**NEI 99-02 FAQ 19-02 (Proposed NRC Response)
Brunswick RCS Leakage**

Plant: Brunswick Nuclear Power Plant Unit 1

Performance Indicator: BI02 - Reactor Coolant System Leakage

Figure 1, RCS Leak location

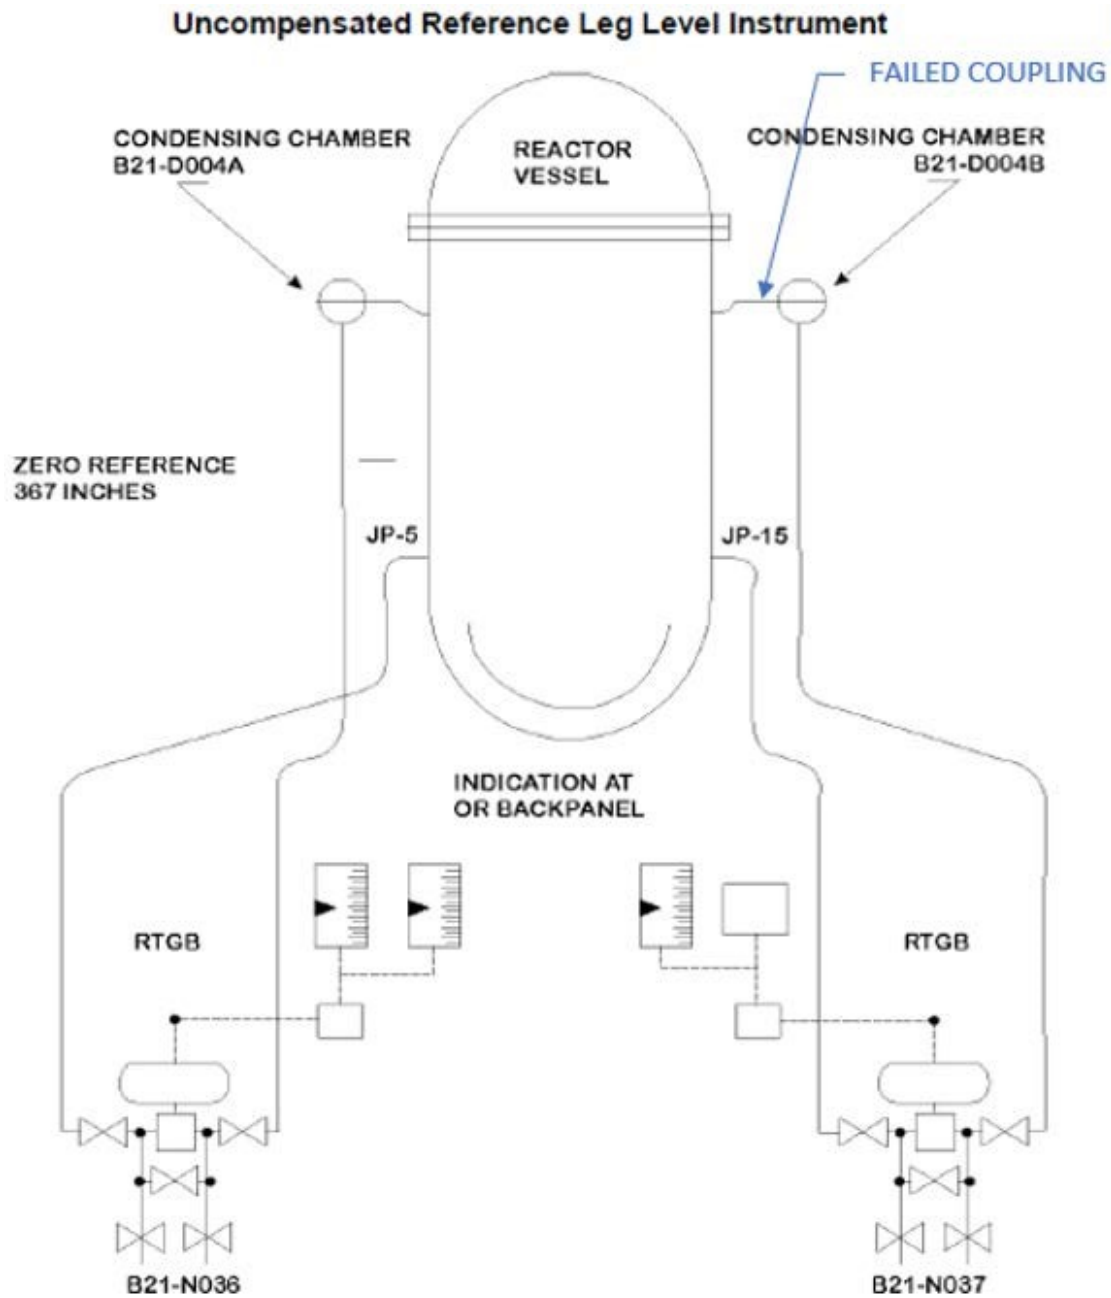
Investigation inside containment determined that a 1-inch coupling on line 1-B21-774 located on the steam side of a reactor level condensing chamber experienced a 360° circumferential separation at the approximate center of the coupling as shown in Figures 1 and 2 below. This opened a path for steam from the reactor to leak into the drywell. Reactor water level was maintained in the established level band, below the level of the sensing line nozzle, throughout the event. The impact from the coupling failure has been analyzed by the Duke Probabilistic Risk Assessment staff and determined to be very low safety significance.

Figure 2, Picture of failed 1-inch coupling:

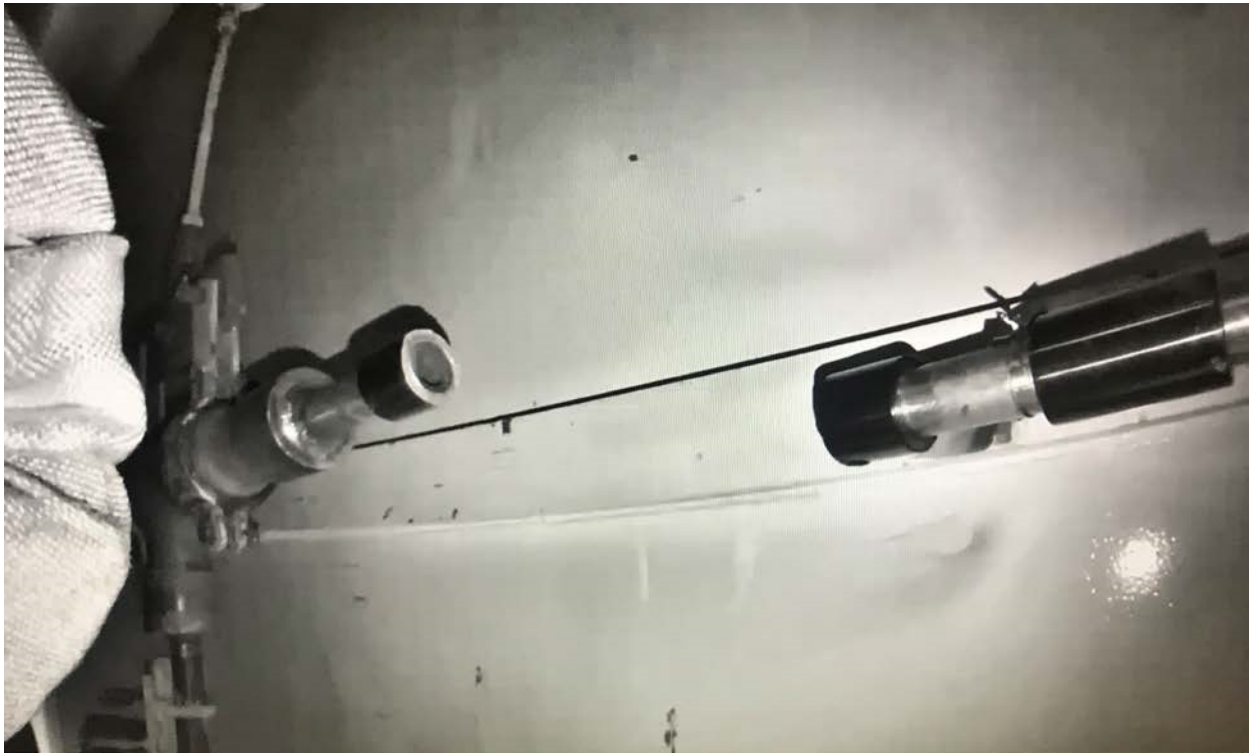
A Root Cause Evaluation was initiated following the March 28, 2019. The coupling that failed was a 1" Cryofit (cryogenic) coupling. Cryofit couplings are devices used to connect small bore piping (1-inch nominal pipe size and less) without welding. They are fabricated from a shape memory alloy (SMA) material composed primarily of Nickel-Titanium-Iron (Tinel) which experiences a phase change at cryogenic (extremely low) temperatures. To prepare for installation, the Cryofit coupling is cooled below the transformation temperature. The ends of the coupling are then expanded and the coupling is stored in the cold, expanded state. The pipe ends are inserted into the coupling while it is cold. The phase change causes the coupling to shrink as its temperature rises from its installation temperature of less than -200° F to ambient temperature and above. This results in an interference fit that does not require welding. This unique effect is produced by a phase transformation, i.e., an instantaneous shear transformation between the alloy's body-centered cubic austenite phase and its highly twinned martensite phase. These couplings had been installed at Brunswick for approximately 30 years.

Figure 3, March 2019 Reported RCS Leakage (4-hour periodicity)

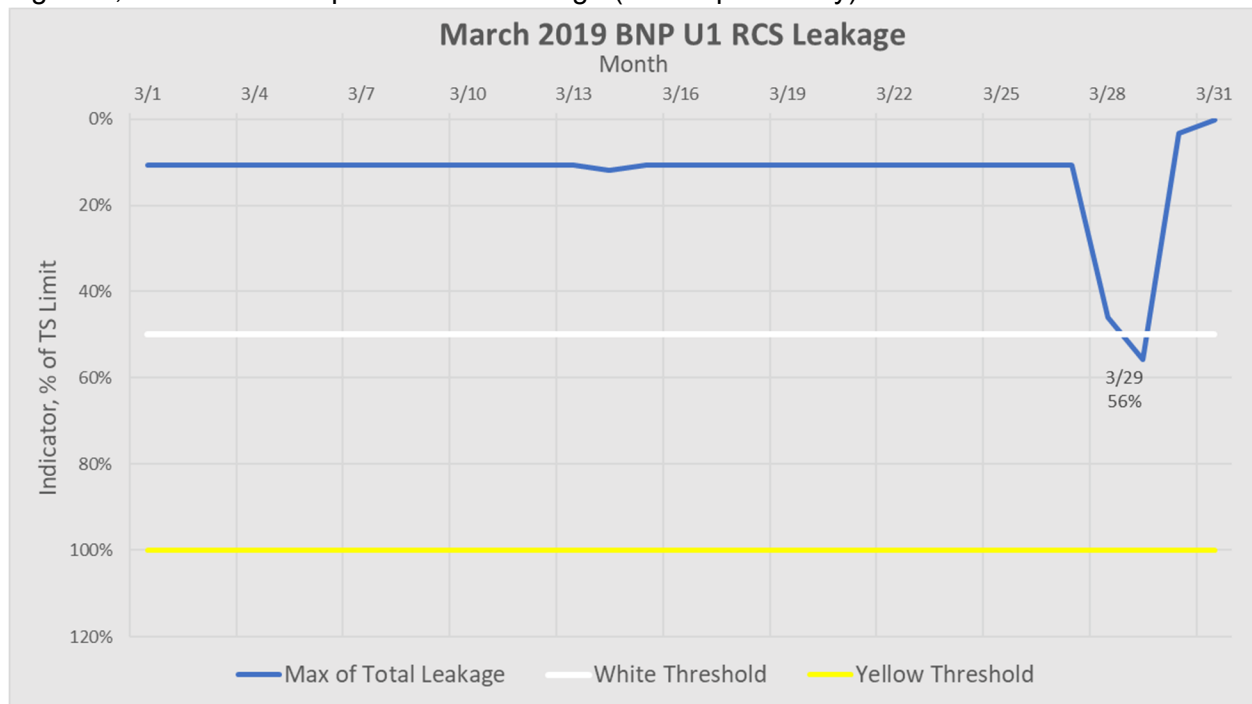
The PI is intended to monitor leak-before-break situations that are viewed as precursors of a more catastrophic failure. In the Brunswick event, RCS Total leakage had been steady for the month of March as shown below in Figure 3. There was no advanced indications of degradation or leakage from the coupling and no trend that worsened over time due to operator inaction.

As shown in Figure 3, RCS Leakage trends were stable and low in the Green performance band for the month leading up to the coupling failure. The coupling failure occurred without warning. Drywell leakage and temperature in the vicinity of the coupling did not increase prior to the failure. There was no opportunity for Operations staff to identify this condition in advance of failure. As no precursors were present, no mitigating actions could have been taken in advance of the leak and the actions taken following the leak indicate prompt and conservative response on the part of the licensee. In addition, the location of the leak prevented it from being isolated until the plant was depressurized, which added to the volume of the leakage calculated in the PI. Despite timely operator actions to accomplish this, the volume of leakage calculated in the PI resulted in one calculation data point exceeding the threshold for White. The degradation mechanism of the coupling will be evaluated under other NRC processes.
